**MODIFICATION REQUEST:
MP10_0016 MOD 2**

***Scottish Hospital Seniors Housing and
Care Facility***

Environmental Assessment Report
Section 75W of the *Environmental Planning and
Assessment Act 1979*

April 2017

Figure 3: Location of Camphor Laurel trees (in red) and trees 6, 122, 127 and 133 (in blue). (Source: Proponent's EIS)

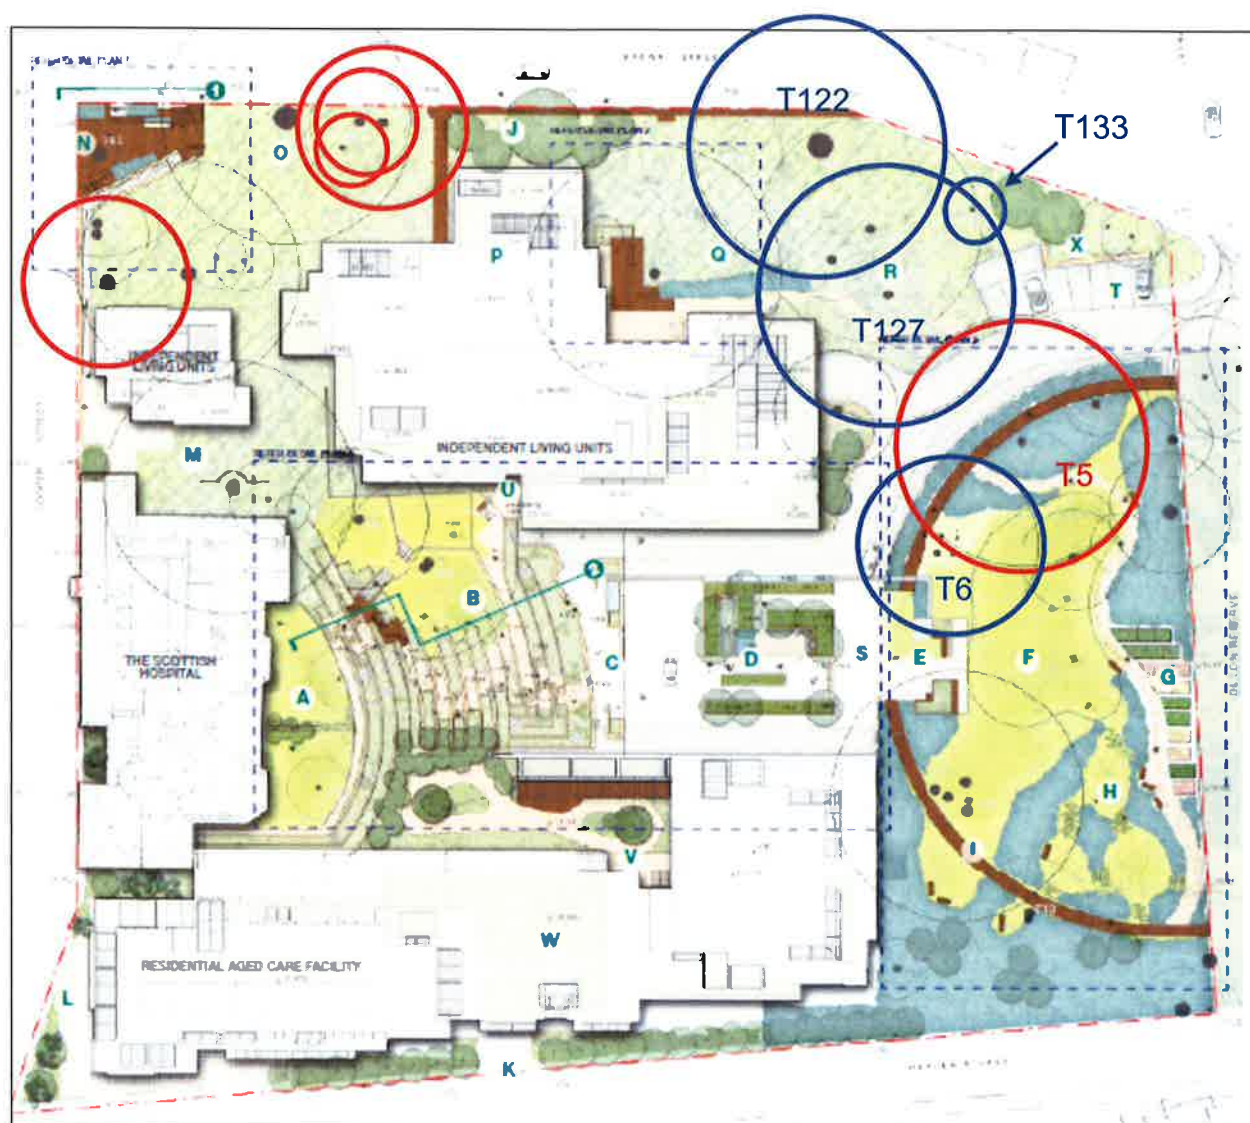
The project approval identifies five Camphor Laurel trees on the site, Trees 5, 89, 106, 107 and 108. The current project approval requires their retention (shown on **Figure 3** in red). As part of the modification, the Proponent requests approval to remove Tree 5. Tree 5 is not heritage listed, however the Arborist Report prepared for the original project approval noted it could be retained due to its good health, size and long life expectancy (Retention Value 'B') (refer to **Photo 1**).

Tree 5 is located in close proximity to two heritage listed trees, Tree 6 (Weeping Lilly Pilly – Retention Value 'A') and Tree 122 (Moreton Bay Fig – Retention Value 'A'), as well as native Tree 127 (Port Jackson Fig – Retention Value 'A') and Tree 133 (Magenta Lilly Pilly – Retention Value 'B') (as shown on **Figure 3** in blue and **Photos 2-5**).

The Department has reviewed the information provided and is satisfied the Proponent has demonstrated that it has explored reasonable options to maximise tree retention. Based on this information, the Department considers it acceptable to remove Tree 5 in order to achieve safe vehicular access for construction, and to minimise the impacts on neighbouring, more significant trees. The Department therefore supports the removal of Tree 5 and replacement with a 'super-advanced' Port Jackson Fig.

The Department recommends a condition of approval outlining the requirements for the replacement tree, specifically that Tree 5 is to be replaced with *Ficus rubiginosa* – Port Jackson Fig, and shall be 1,000 litres at the time of installation. The replacement tree is to be located within 10 metres of the current location of Tree 5.

Figure 4: Road alignment if Tree 5 is retained (Source: S75W modification request).

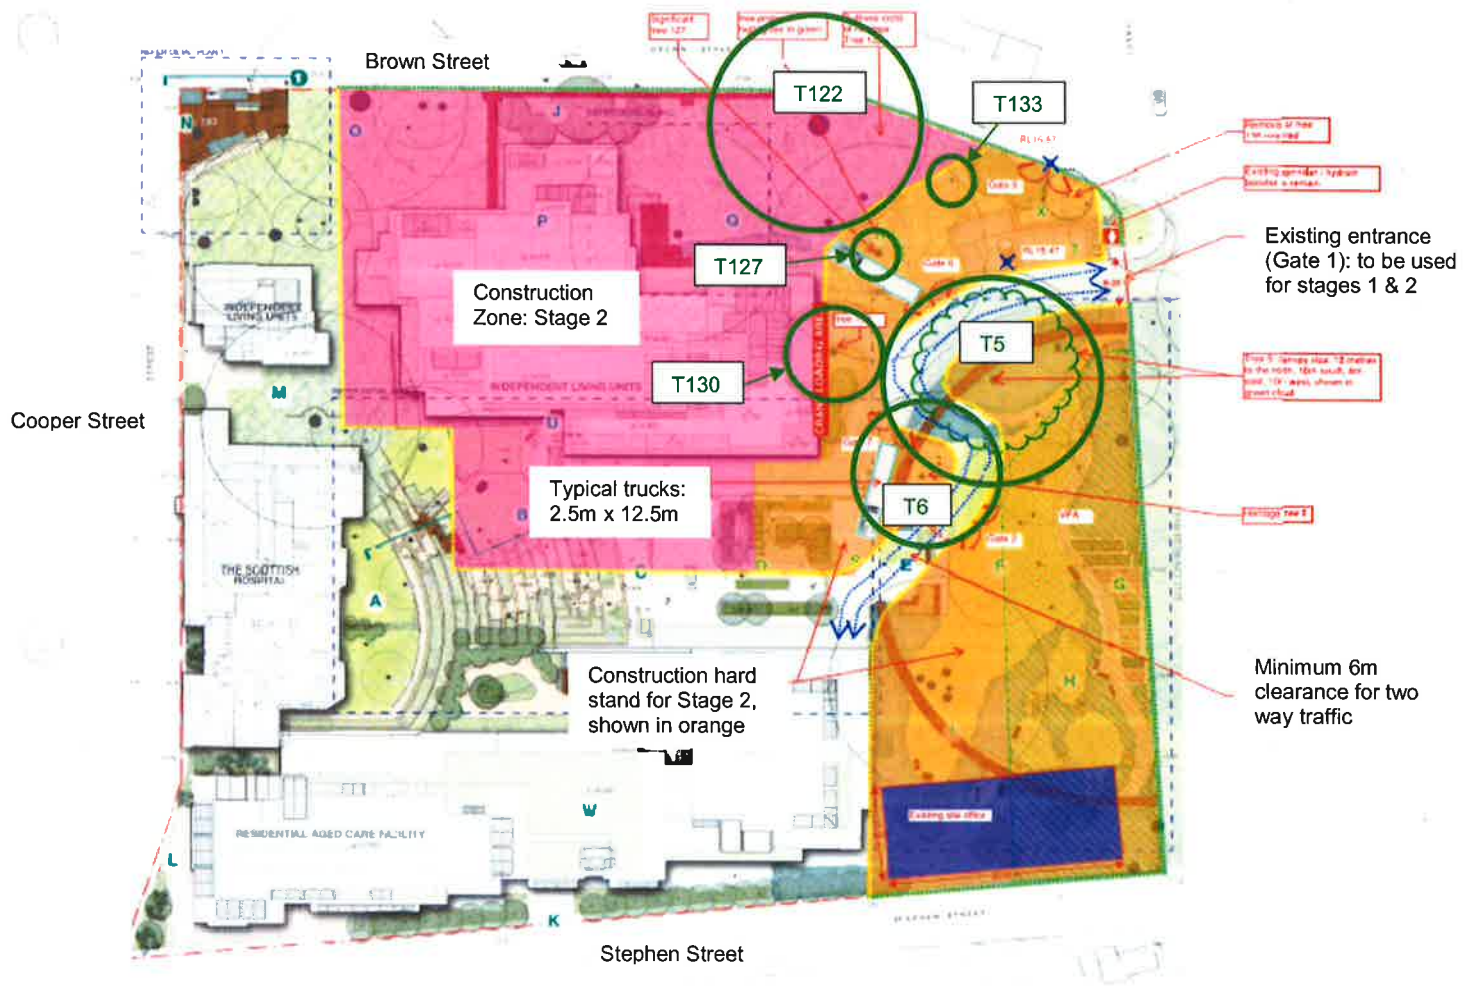
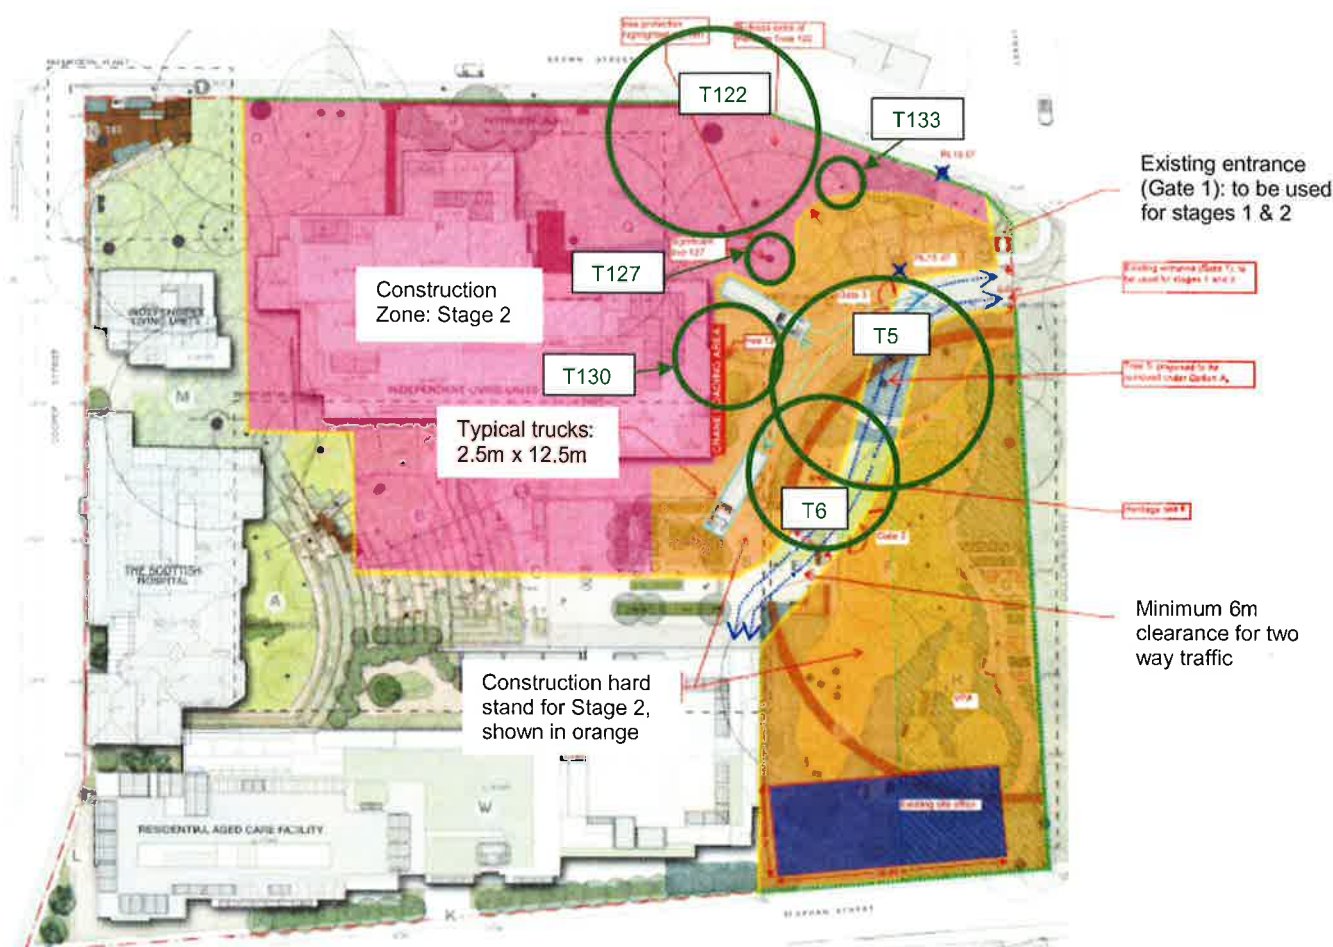
In response, the Proponent advised that in order to retain Tree 5, the access road for construction vehicles and Stage 1 of the development would bend around and between Trees 5 and 6 and that heavy vehicles would need to manoeuvre within 1-2 metres of Tree 127. This would not allow for tree protection fencing to be installed and would call into question the ability to retain Tree 127. The Proponent also explored an alternate location for access at Gate 5, however this was not suitable due to the significant level change between the street and the site in this location, the need to retain two trees and external traffic conflicts. The road alignment if Tree 5 is retained is shown in **Figure 4** and the road alignment if Tree 5 is removed is shown in **Figure 5**.

The Department considers the retention of Tree 5 creates an unviable and unsafe traffic environment during the Stage 2 construction works for the following reasons:

- the construction of the driveway around Trees 5 and 6 results in two hairpin turns and blind spots leading to safety risks; and
- trucks would be required to reverse on the access driveway, which provides access to Stage 1 of the development which will be in operation.

The Department notes the proposed access and trucks movements to accommodate the retention of Tree 5 would impact on adjacent significant trees on the site:

- Tree 127 – trucks would manoeuvre within 1-2 metres of Tree 127, which would not allow for adequate tree protection fencing around the tree to ensure its long term retention; and
- Tree 6 – trucks would manoeuvre within the tree protection zone (TPZ) of Tree 6.

Figure 6: Location of Sydney Red Gum trees (shown in red) (Source: Proponent's EIS)

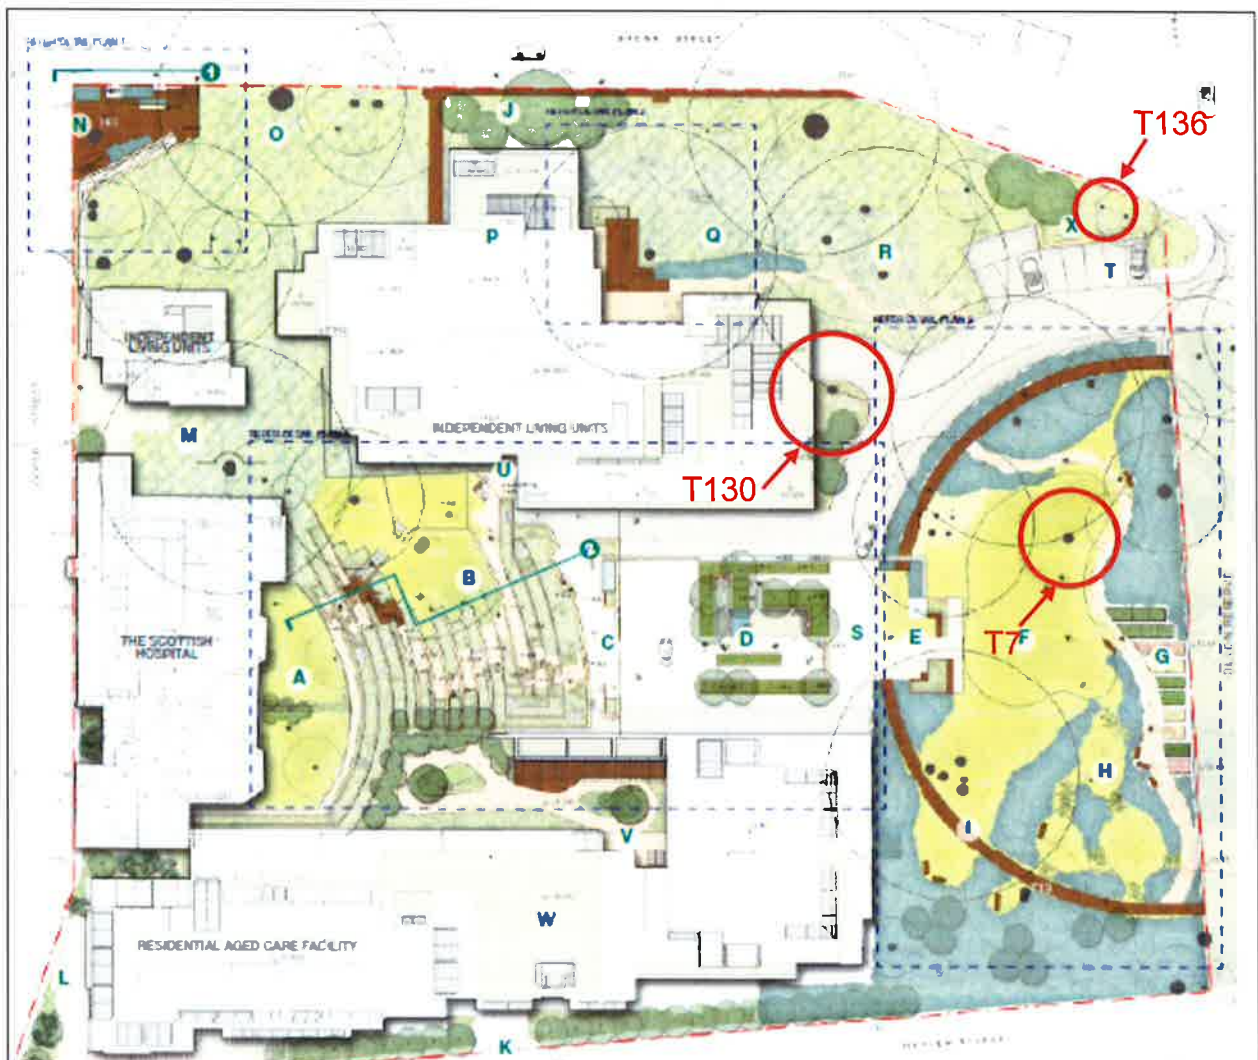
The project approval identifies three Sydney Red Gum trees on the site, Trees 7, 130 and 136, which are to be retained as part of the approved development (**Photos 6 – 7** and **Figures 4 – 6**).

The Proponent requests approval to remove Tree 130, on the basis that the tree location was misinterpreted in the original application. Further review of the location of the point at which the trunk comes out of the ground suggests it is approximately 2.6 metres further north-west of its originally interpreted location. Critically, it is within one metre of the approved location of the basement driveway ramp whereby significant excavation is required within the structural root zone of the tree (**Figure 7**).

Public submissions object to the removal of this tree as the species is protected under the Woollahra Tree Preservation Order, and that inadequate justification has been given for its removal. Concerns were also raised about the suitability of the originally proposed Christmas Bushes as a replacement for the Sydney Red Gum. The Department notes that the Proponent has subsequently agreed to replace Tree 130 with a 100L Sydney Red Gum located 15m southeast of its current location.

The Department notes the arborist report prepared for the project approval rated the tree as Retention Value 'A', being it should be retained due to its good health and long lifespan. It is also noted that the tree is important to the community due to its species and size.

The Department therefore supports the proposal to remove Tree 130 and replace it with an advanced Sydney Red Gum in a more suitable location, allowing the tree to grow without the constraints of the existing location. This will also address concerns raised by the community regarding loss of this species of tree and ensure that a healthy similar replacement tree is provided in a suitable location to ensure its long term health and viability.

The Department recommends a condition of approval detailing the requirements of the replacement tree, specifically that Tree 130 is to be replaced with the same species (*Angophora costata* – Sydney Red Gum), and shall be a minimum pot size of 400 litres. The replacement tree is to be located in the garden bed adjacent to the approved building in the same area as the current location of Tree 130.

Figure 7: Excerpt from Site Plan, DA101 Rev. P11 (Source: S75W modification request)

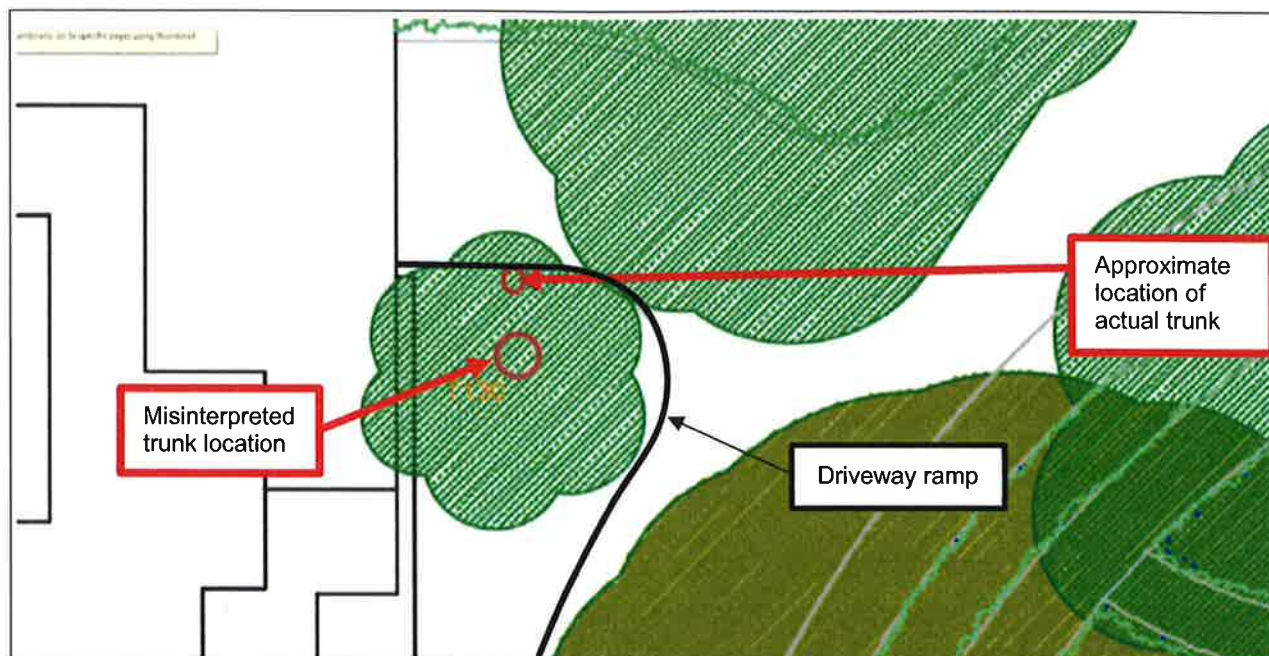
The Department also notes the approved excavation and basement driveway works will result in root cutting and are likely to adversely affect the stability and health of the tree. Additionally, substantial crown pruning would be required to allow for the proposed building façade works, which would significantly disfigure the tree. The Department considers the impacts of the works in combination would significantly reduce the tree's long term retention value and reduce the landscape amenity provided by the tree.

Figure 8: Brown Street Theatre. (Source: S75W modification request)

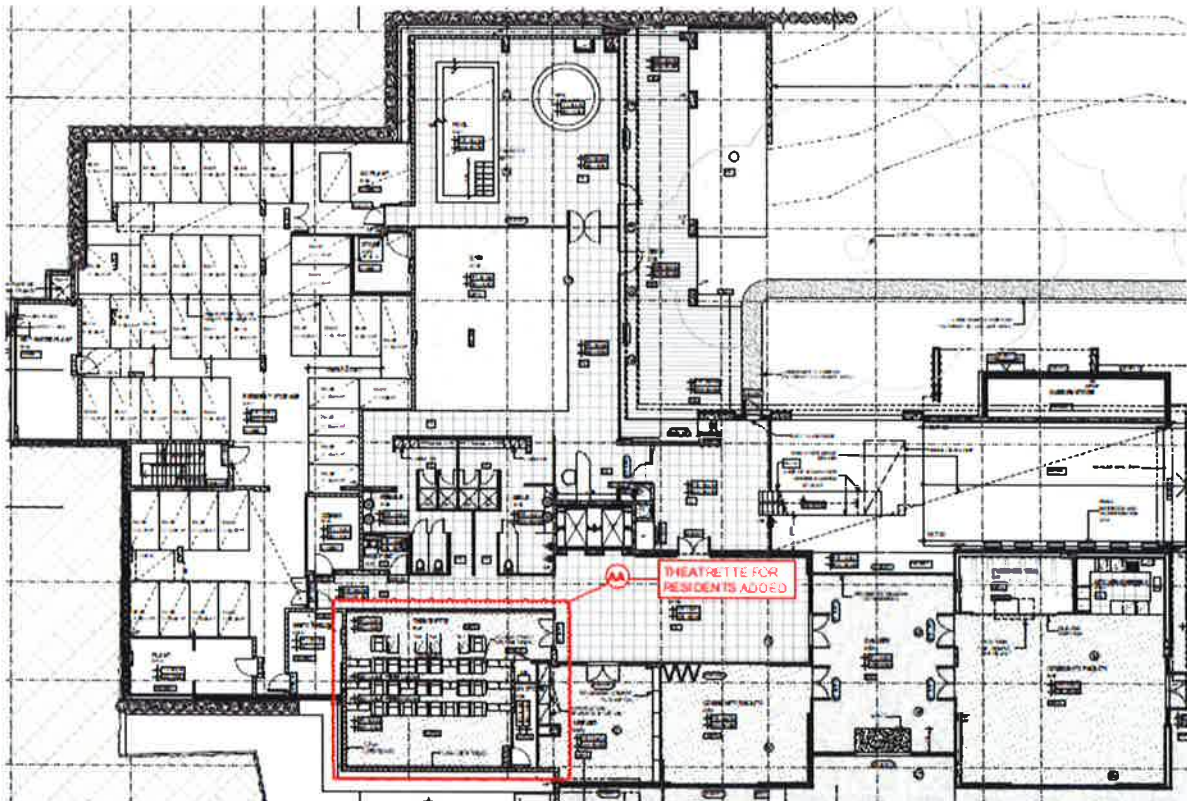
The Proponent is seeking to convert an approved storage area in the basement of the Stephen Street building to a theatre for use by residents of the Aged Care Facility (**Figure 8**). The total GFA will increase by 80m² as a result of the conversion, however the external appearance of the building will be unaffected.

Two public submissions object to the conversion of this space into a theatre and raised concerns about the increase in GFA, as well as the potential for increased traffic and visitor impacts. The Proponent's RtS confirms the theatre will be used by residents only, and therefore no traffic impacts will occur as a result of the proposed conversion.

The Department considers the addition of a theatre will provide an additional facility for residents, improving the overall amenity of the Seniors Housing and care facility. As the theatre will be used by residents only, it will not generate any additional traffic impacts. The Department therefore supports the conversion of the basement storage area to a theatre.

Figure 9: Stephen Street Void. (Source: S75W modification request)

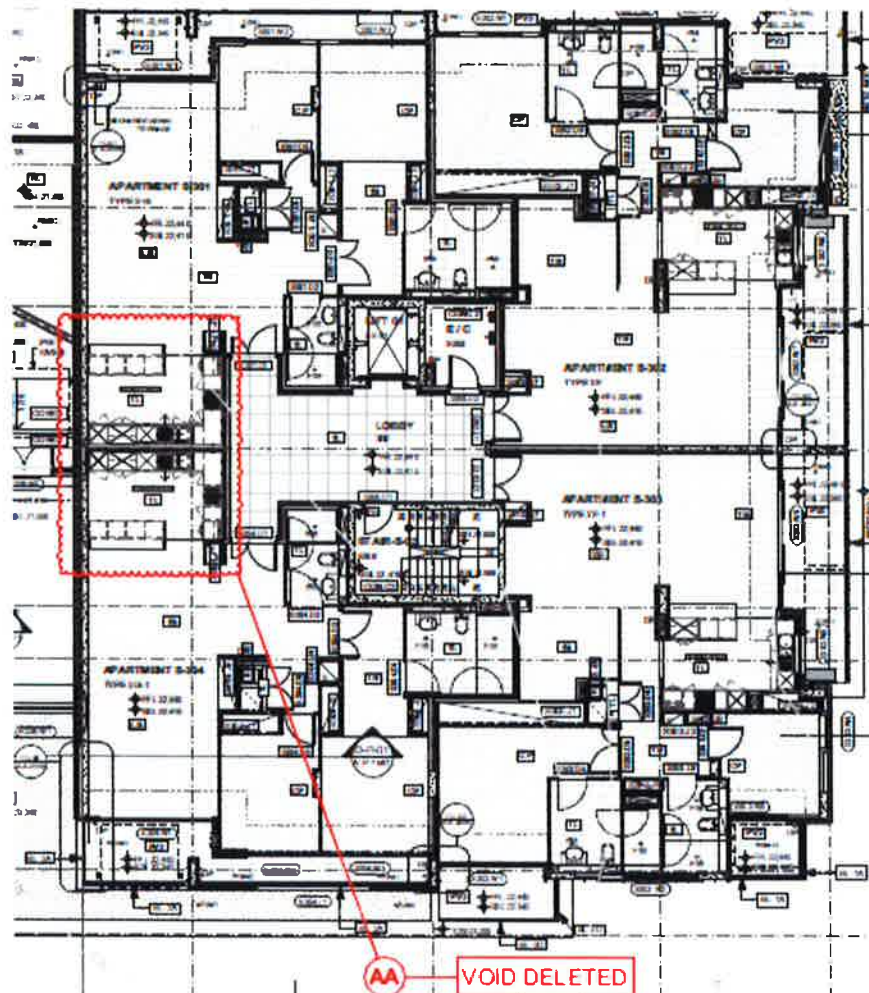
The proposal seeks to enclose an approved void (a double height space) in Level 3 of the Stephen Street building (**Figure 9**), and convert the additional floor space to expand the kitchen floor space of apartments S-310 and S-304 (consistent with the floorplans of other levels). This will increase the total GFA by 14m². The Proponent submitted a BCA Statement demonstrating that the approved void does not comply with the BCA in terms of fire safety.

The Department supports this element of the modification, noting the increase in GFA will be negligible in the context of the overall development, and the overall bulk and appearance of the building will remain the same. The enclosure of the void will also provide a larger kitchen in two apartments which will enhance their level of amenity.
